RECORD OF DECISION

Operable Unit Two
Old Roosevelt Field Contaminated Groundwater Area Superfund Site
Nassau County, New York

United States Environmental Protection Agency
Region 2
New York, New York
March 2018

Figure 2
Conceptual Design for Alternative 2
Pump and Treat
Old Roosevelt Field Contaminated Groundwater
Area Site, Operable Unit 2
Garden City, Nassau County, New York

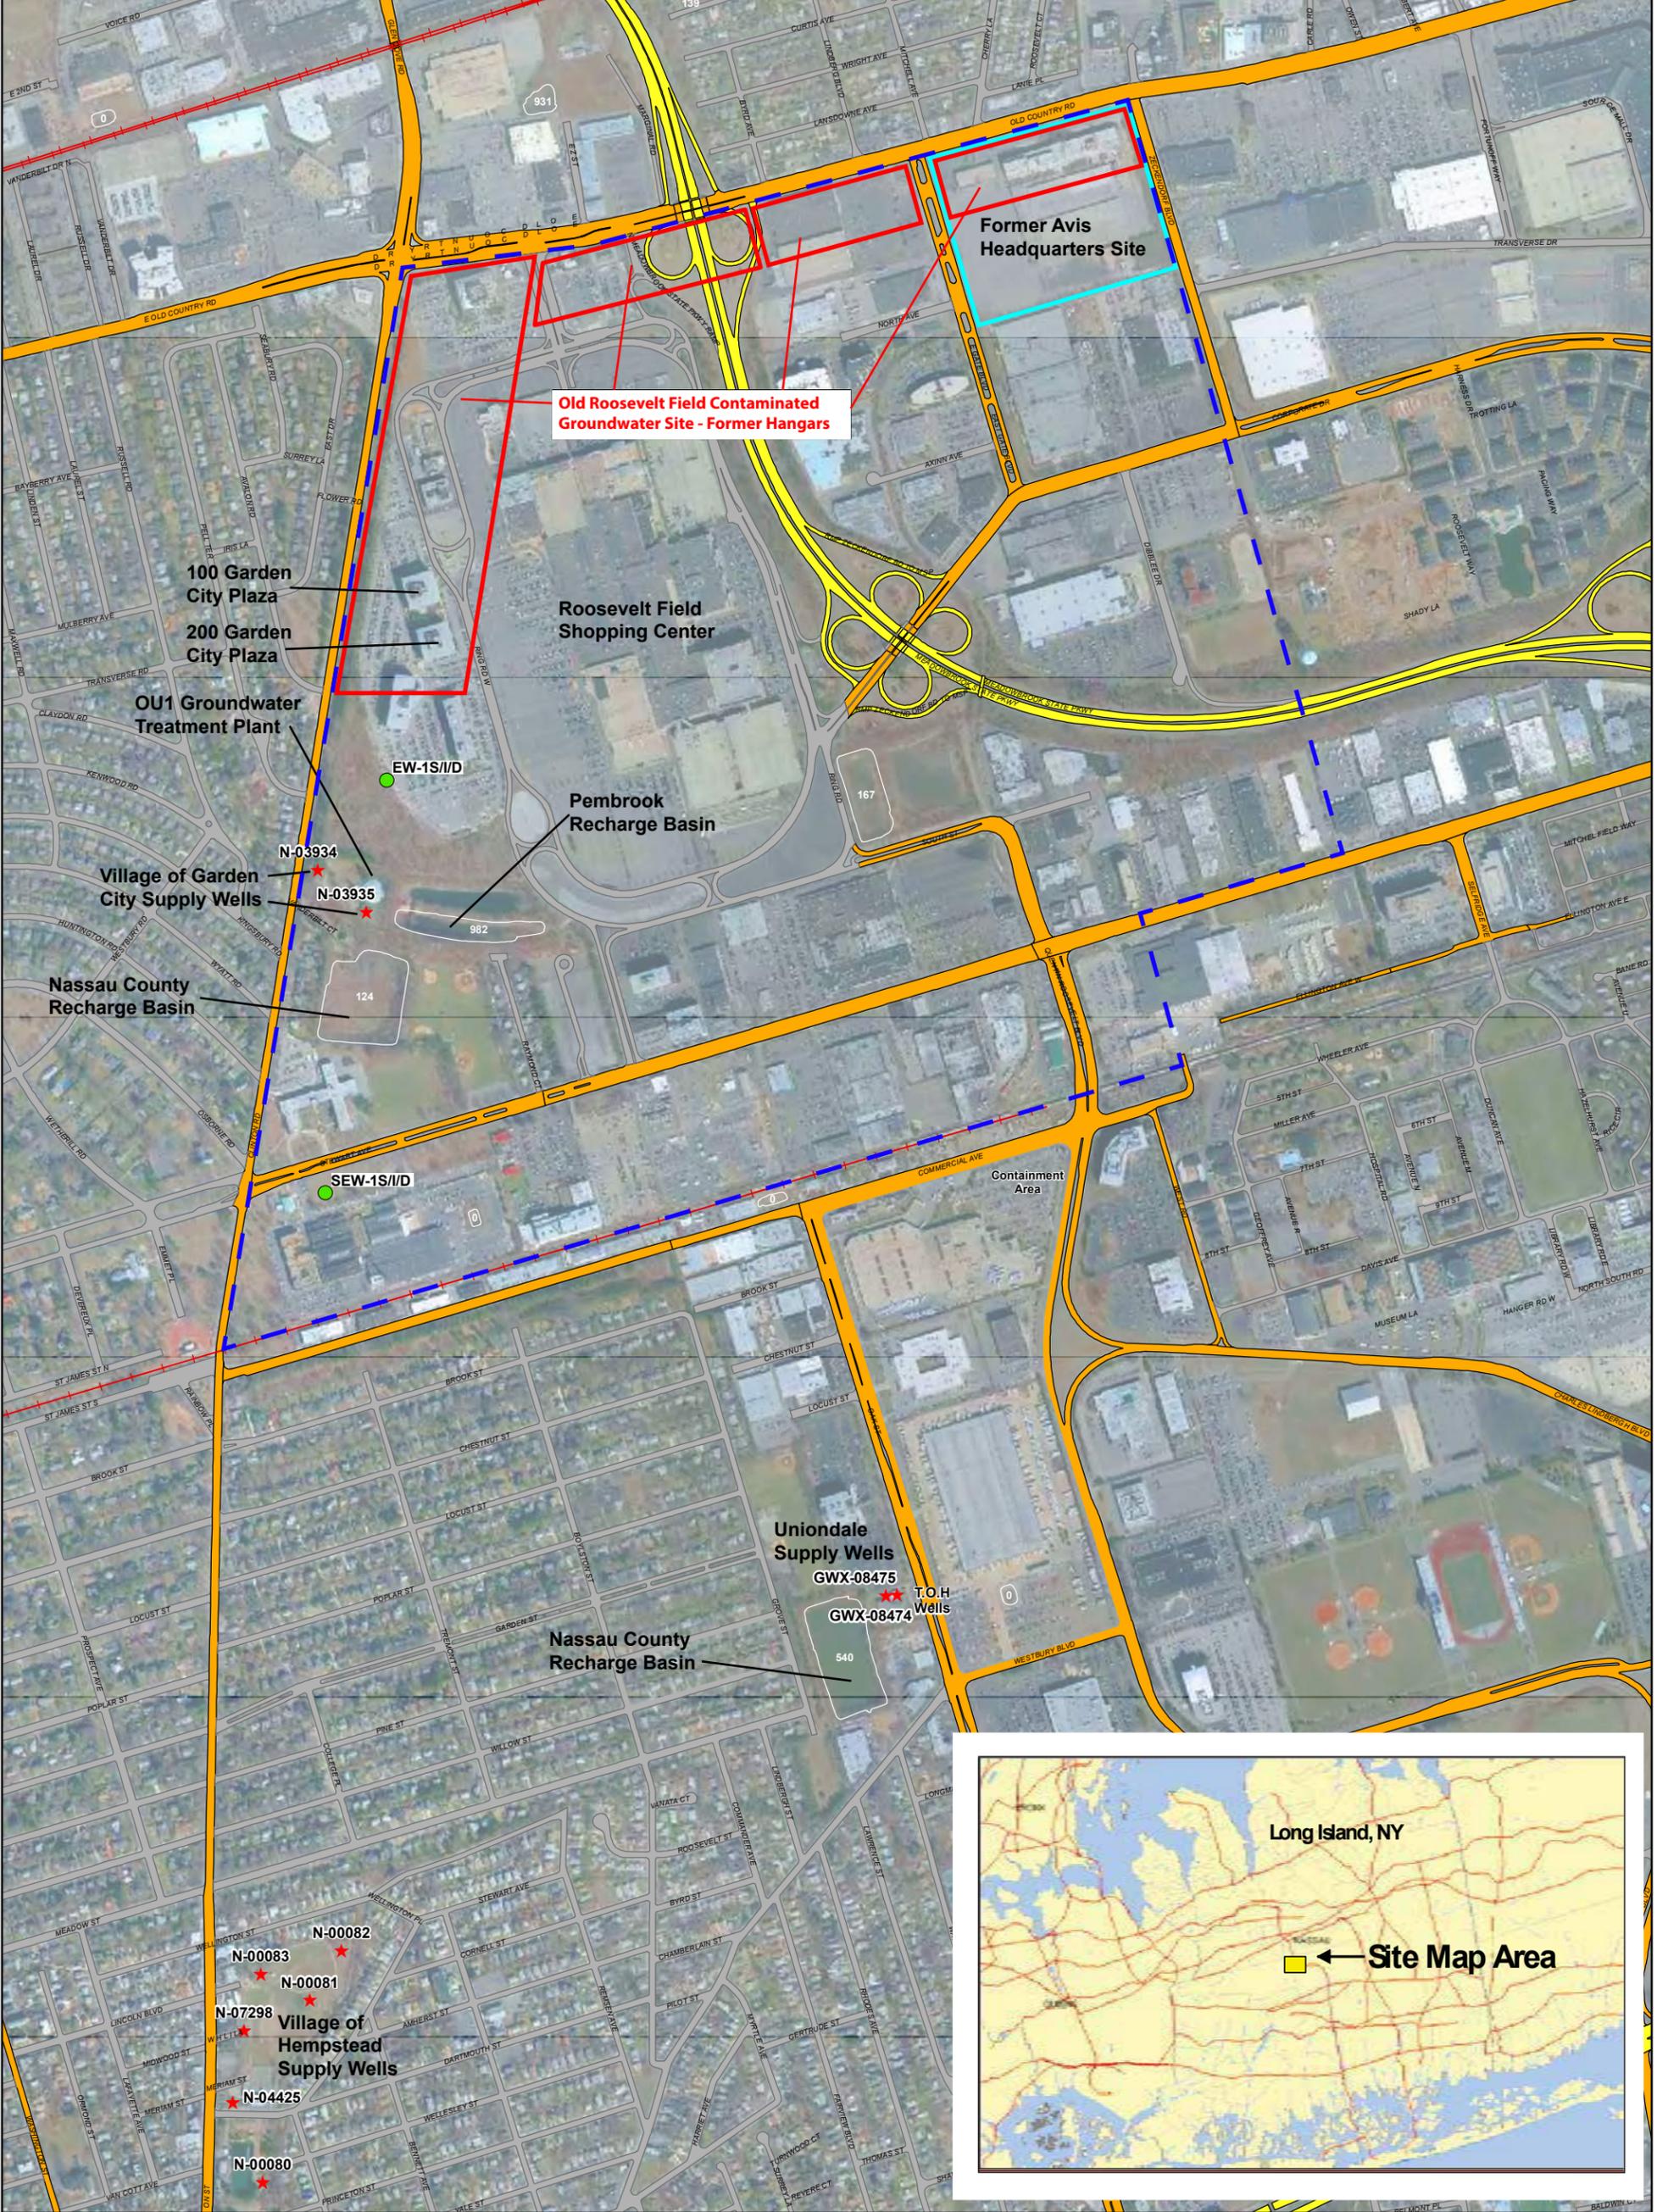
Comment # 13: A commenter expressed concern about contaminant concentrations near his home and requested clarification on what is being represented by the dotted line depicted on Figure 2 of the proposed plan.

Response to Comment # 13: Figure 2 of the proposed plan shows the current extent of groundwater contamination based on the RI. The lines are contours of equal concentration level, for example 5 parts per billion of PCE. The lines are dotted where they have been inferred, typically based on groundwater modeling or other hydrogeologic data because it is not feasible to collect and analyze ground water samples everywhere.

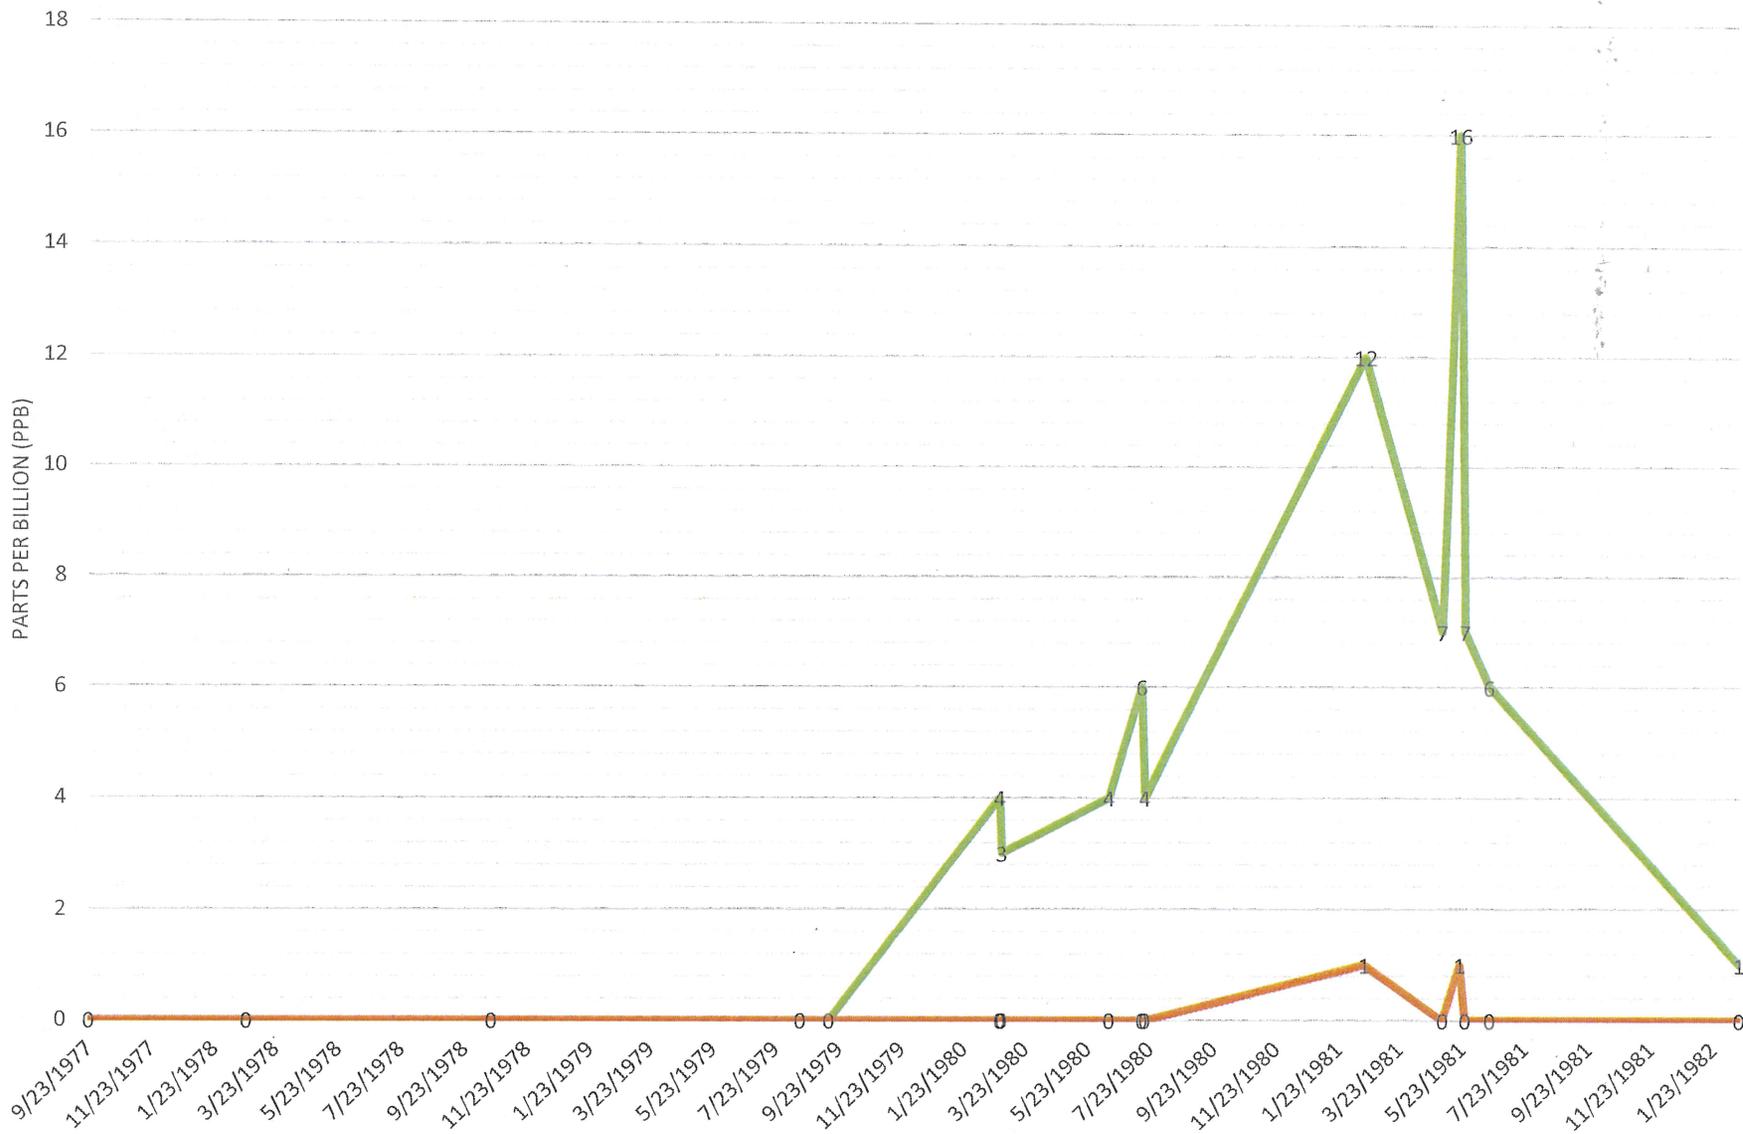
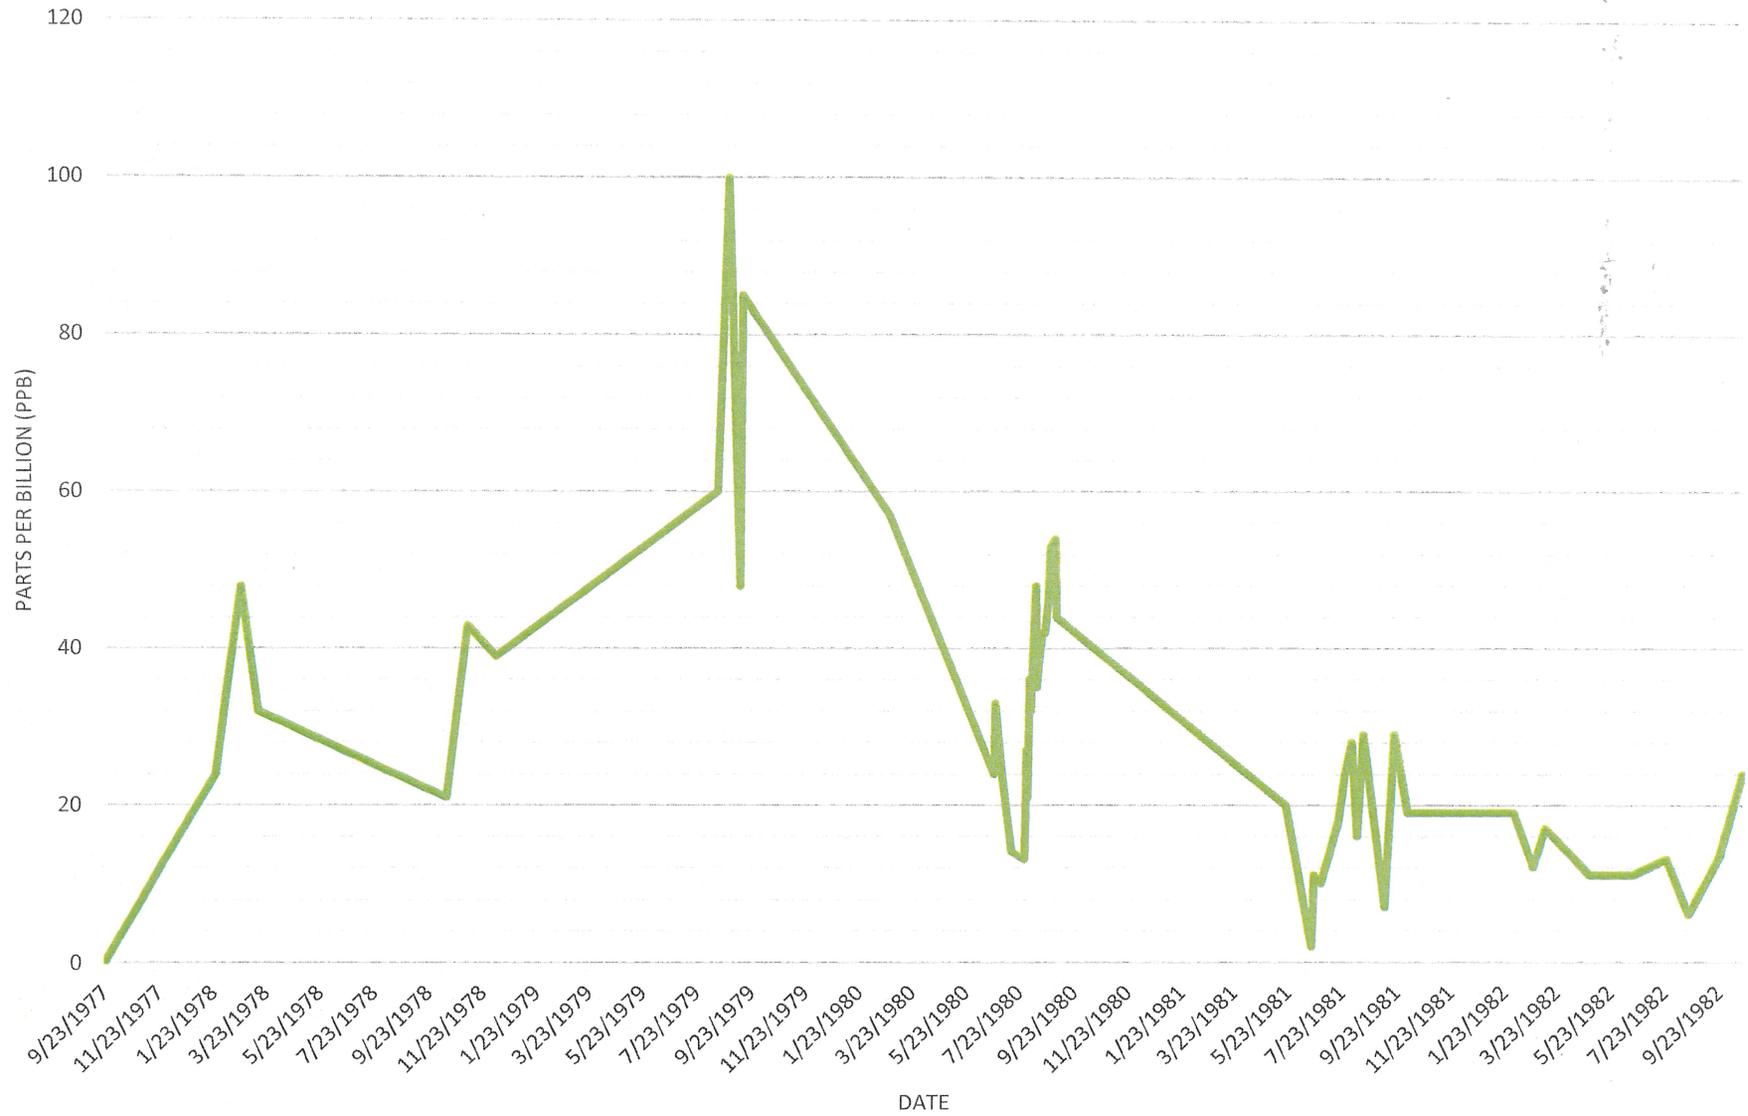
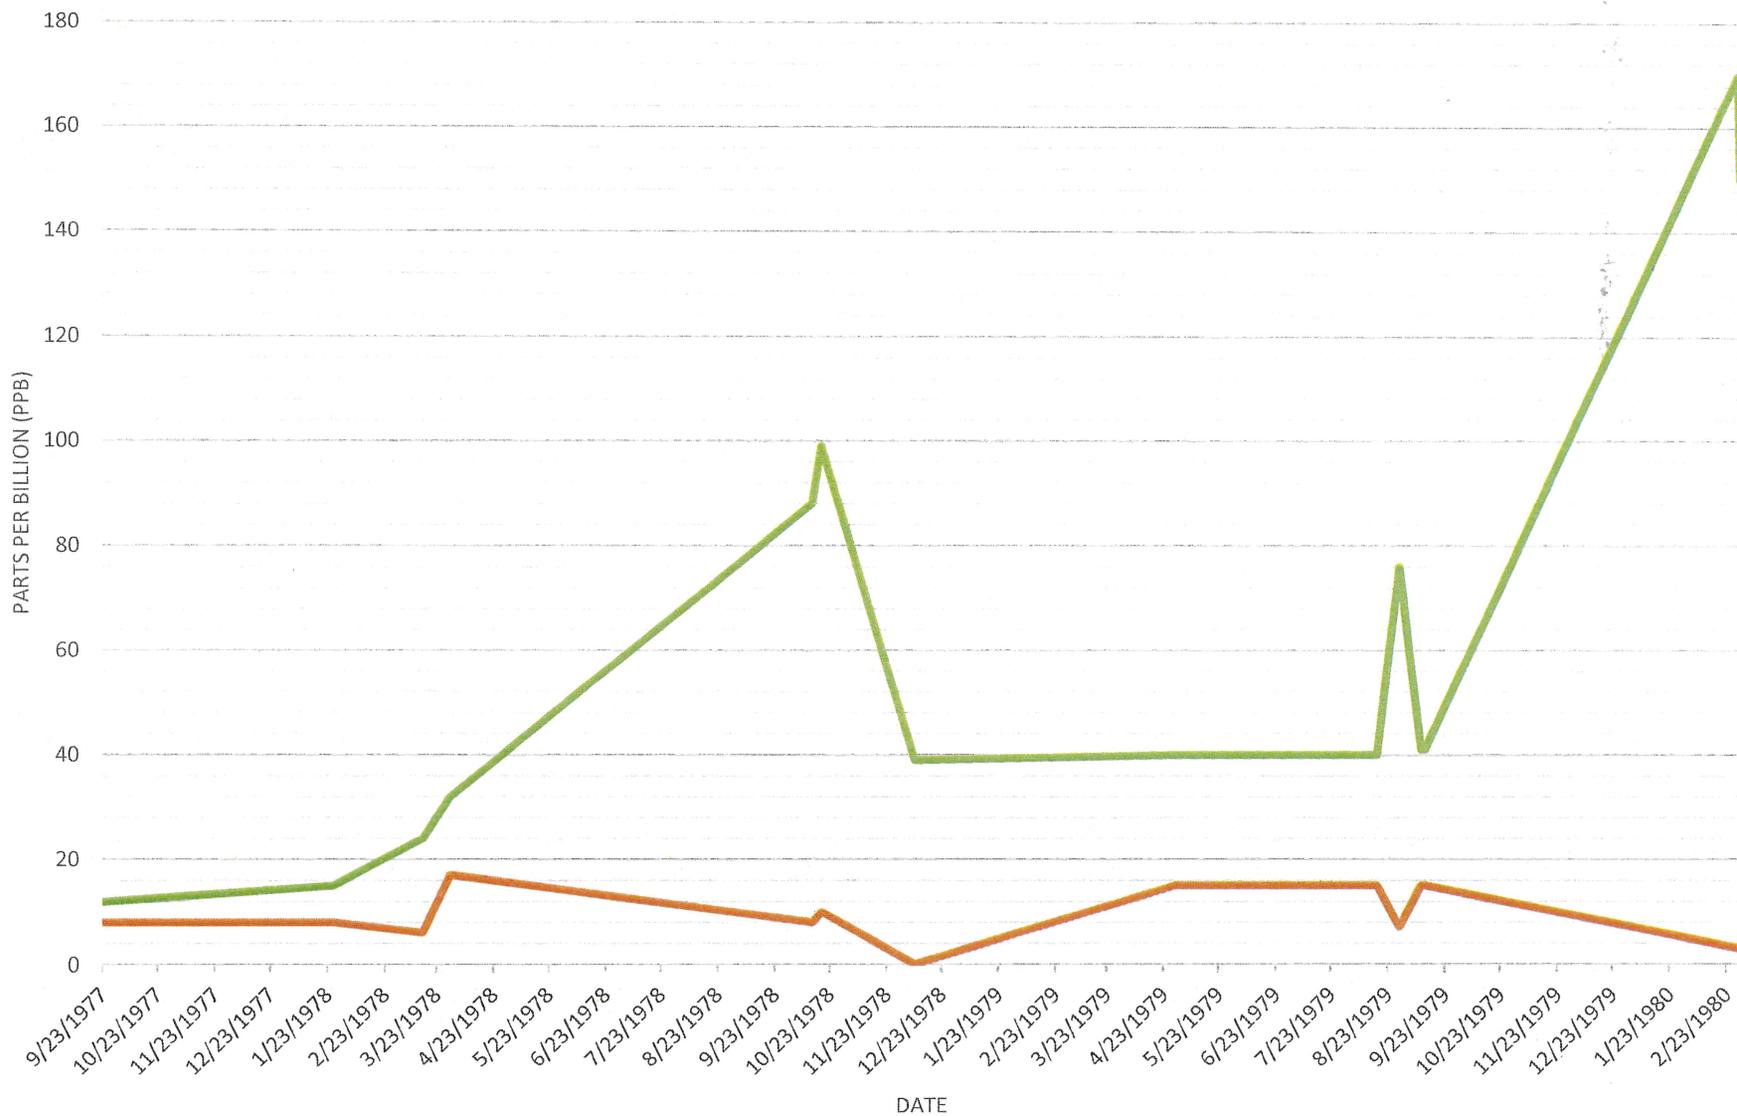
Comment # 9: A representative from Nassau County Department of Public Works expressed general agreement with both the conceptual model proposed for the Site and the identification in the RI Report of the historic source area located in the intermediate zone (250 to 400 feet below ground surface). The representative requested that EPA consider modifications to the conceptual site model and interpretation of the intermediate and deep zones of contamination based on construction and operation details provided for public supply and cooling wells in the area.

Response to Comment # 9: The comments in support of the conceptual model and the historic source location are noted. Updating the 3-D finite element groundwater model for conditions in the 1970s to simulate contaminant fate and transport would be challenging, as EPA is not aware of data from the 1970s on the extent of the contamination in the vicinity of the supply and cooling wells identified, or on the level of contamination between the historical sources and the wells. In addition, investigating and compiling pumping data from the public supply and cooling wells during that period would require a significant effort, with uncertainty as to the usefulness or limitations of the simulation without representative data, and is not necessary for purposes of the selected remedy.

EPA recognizes the usefulness of conducting synoptic water level measurements during high stress summer and fall conditions with Uniondale Public Supply Wells, N-8474 and N-8475, in operation in calibrating and updating the existing groundwater flow model to support the design of the location and screen interval of the groundwater extraction wells for the OU2 selected remedy. EPA expects to coordinate with the Nassau County Department of Public Works during the remedial design when the Agency develops the sampling plans and the long-term groundwater monitoring program for OU2.
